04-SF-80 KP 12.7/13.2

SFOBB Seismic Safety Project

Subject: Mandatory Fact Sheet Memo to File

REVISION OF SUPPLEMENTAL MANDATORY FACT SHEET EXCEPTIONS TO MANDATORY DESIGN STANDARDS

FIGURE 2
REVISED EB ENTRANCE RAMP ALIGNMENT

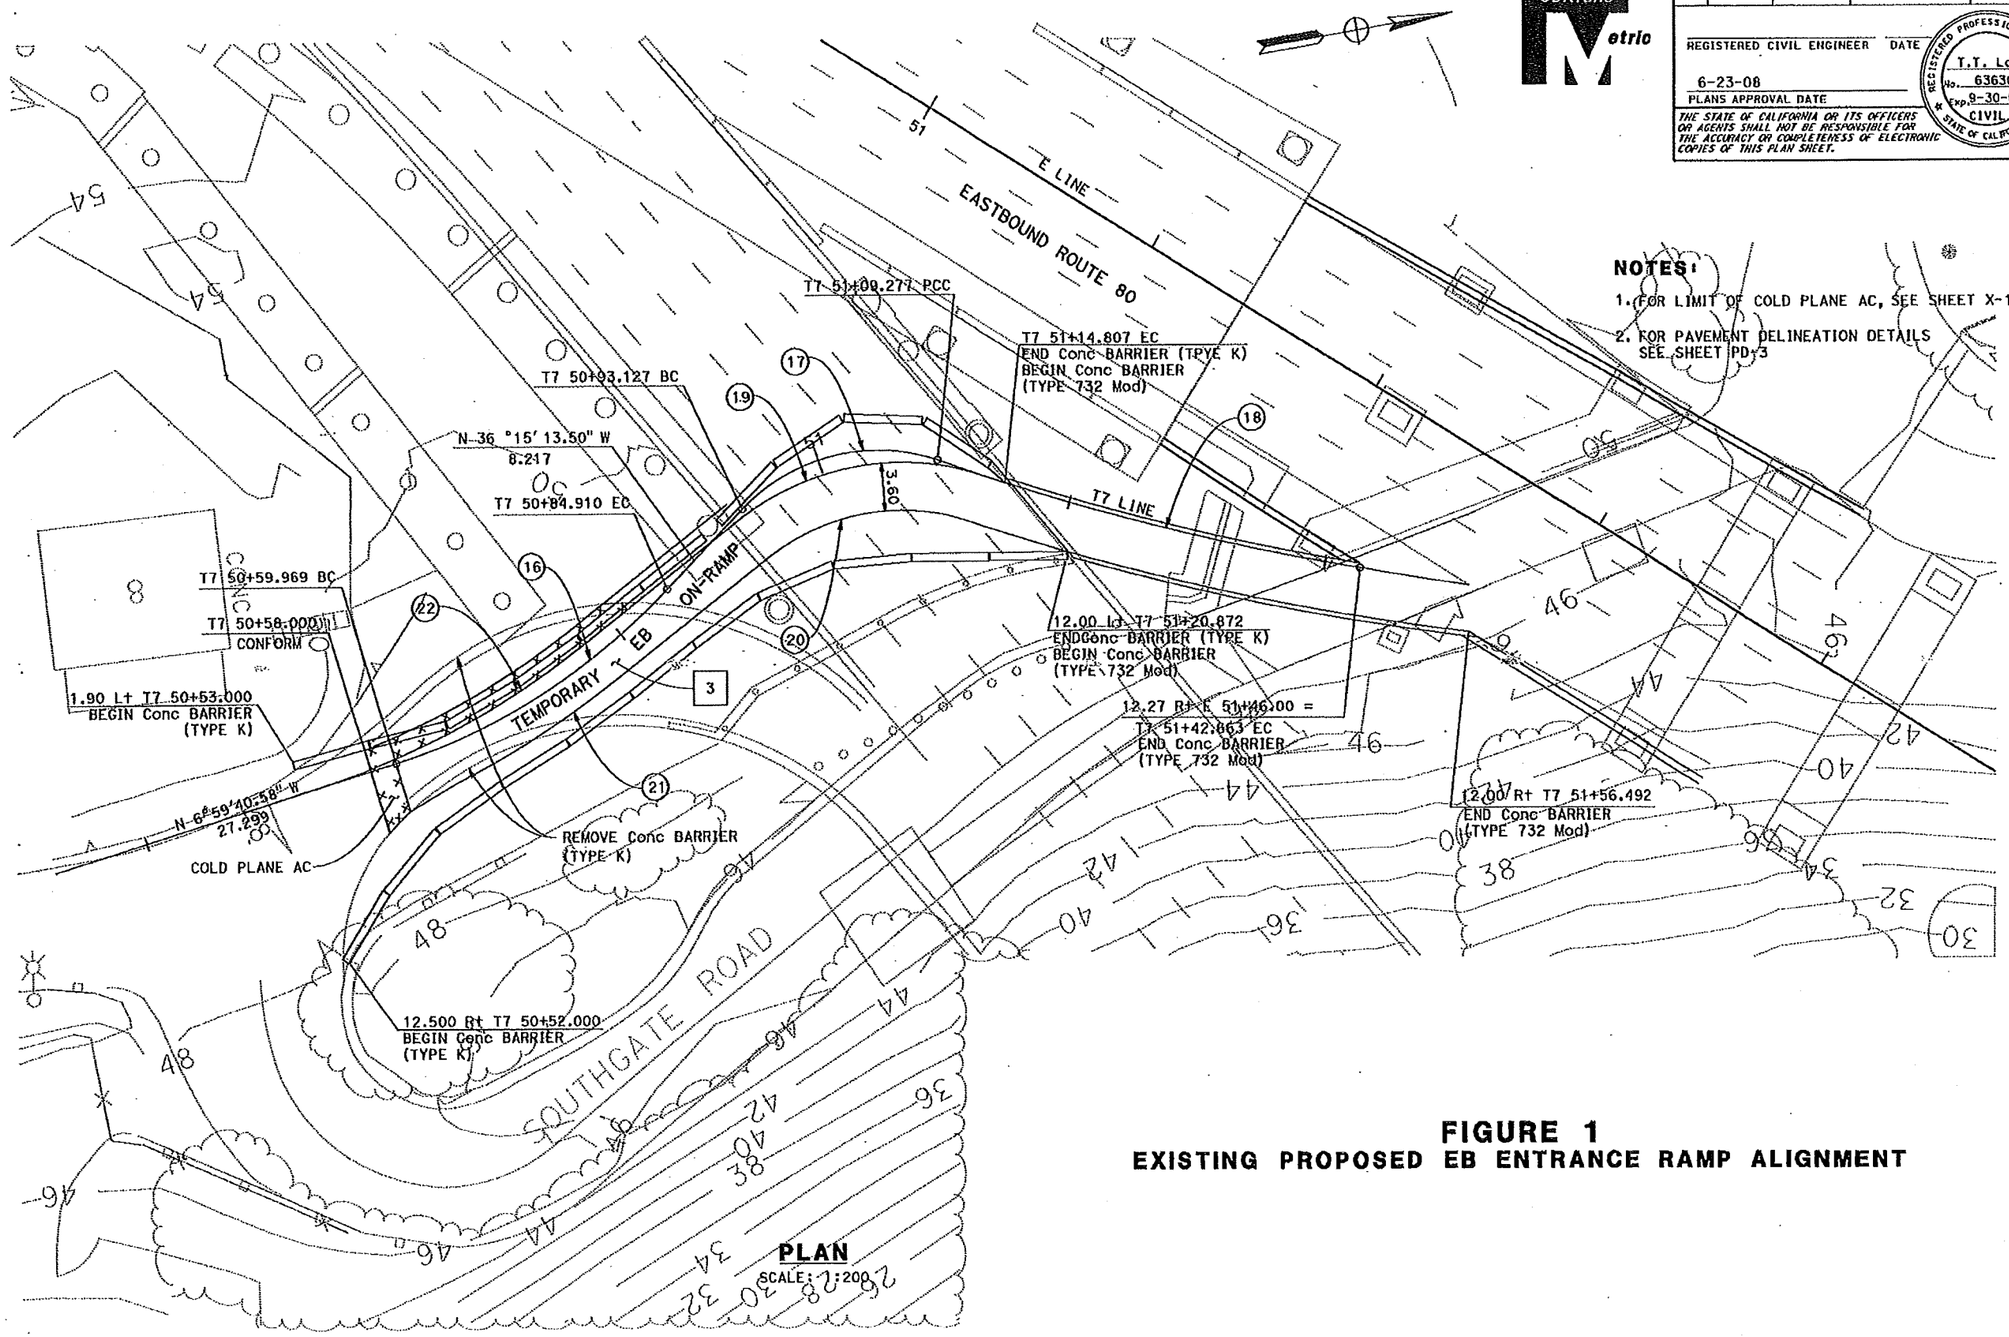
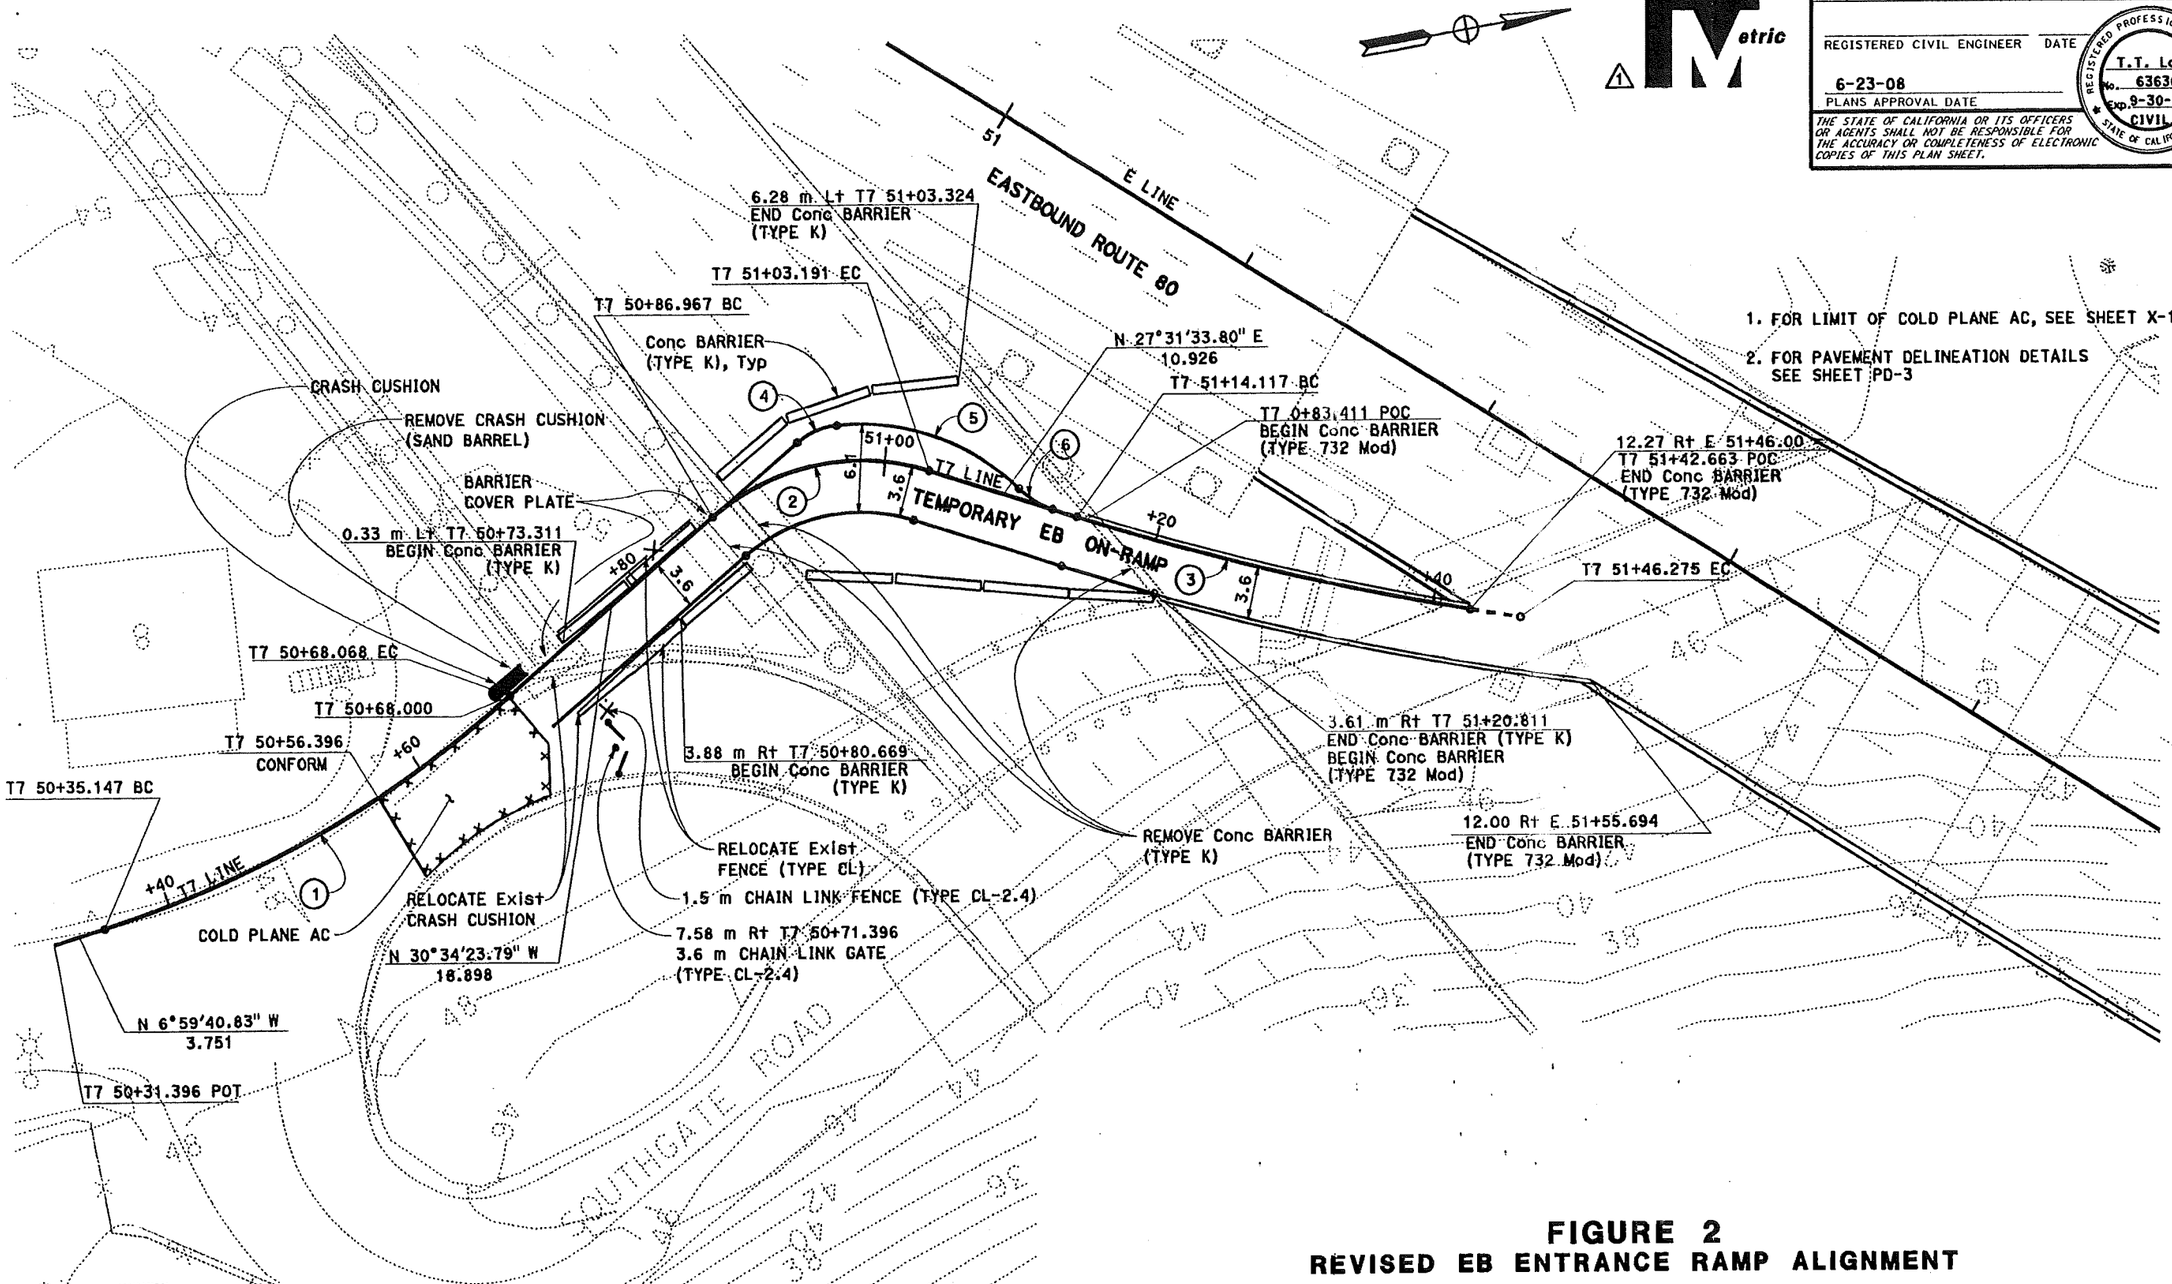
The T7R1 alignment will have a minimum 3.6 meter lane and no shoulders from modified T7 line Station 50+65 to 50+90. Additionally, as stated in the referenced supplemental fact sheet, there will still be the narrow lane width for the previous T7 Line Station plus/minus 50+59 to 51+42. See attachment #1 and #2.

The original proposed temporary EB on ramp is too tight to maneuver for large trucks. The revised alignment will shift to the west to provide more space before the entrance ramp abutment. In order to make this shift in the alignment, the entrance ramp will have to go through a narrow gap between existing columns. See attachment #3.

MARK	DATE	DESCRIPTIONS	REV	CK
1	05/14/13	Revise T7 Alignment	BW	TL
